Report: Issue Data
Function: Test, Adjust, & Balance
Date: 02/05/2026
Completed By: National TAB

PROJECT
CW 9111 - OCC Expansion (Coppell, TX)

Issue List

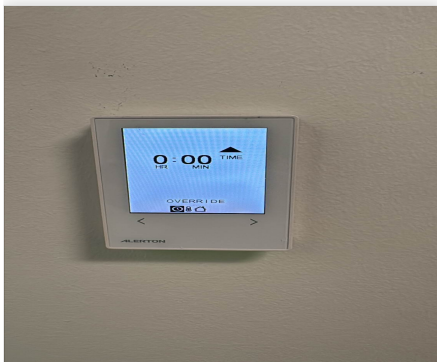
Issue Name : VAV5-3 NOT OPERATIONAL (VAV-2A-30 Controls Label)
Description : Unit is not operational. Unit is showing "NR" on controls graphics. Unit is wired for power and power switch is in ON position. Scrolling through thermostat options and it shows "No Custom Codes". This leads to believe this box has not been programmed. Box shows up on controls graphics matrix for the floor but not on the floor layout page.
